QUALITY ASSURANCE -- NON-CONFORMANCE REPORT

Report No: NCR-000472

Reference Description: Improper storage of fabricated Floor Beam components in Lift 12

Job Name: SAS Superstructure

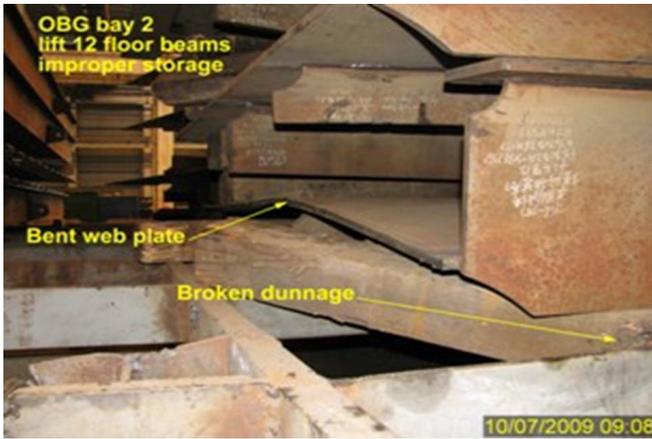
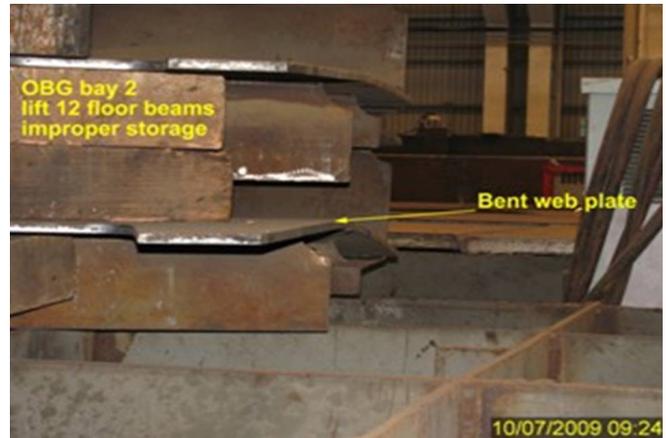
This Quality Assurance Inspector (QA) observed Lift 12 Floor Beam components were bent and warped due to improper handling and/or storage. These Floor Beam components are fabricated and stored in OBG sub-assembly Bay 2.

- 1) Section 6-1.3; Articles or materials to be incorporated in the work shall be stored in such a manner as to ensure the preservation of their quality and fitness for the work, and to facilitate inspection.
- 2) Section 55-1.04; In handling and shipping of the steel work, every care shall be taken to avoid bending, scraping or overstressing the pieces. All pieces bent or otherwise injured will be rejected.
- 3) Section 55-3.09; Finish members shall be true to line and free from twists, bends and open joints.

Submit a repair procedure to the engineer for approval prior to installing these bent and warped components into the work. Correct the storage procedure that lead to the bent and warped components.
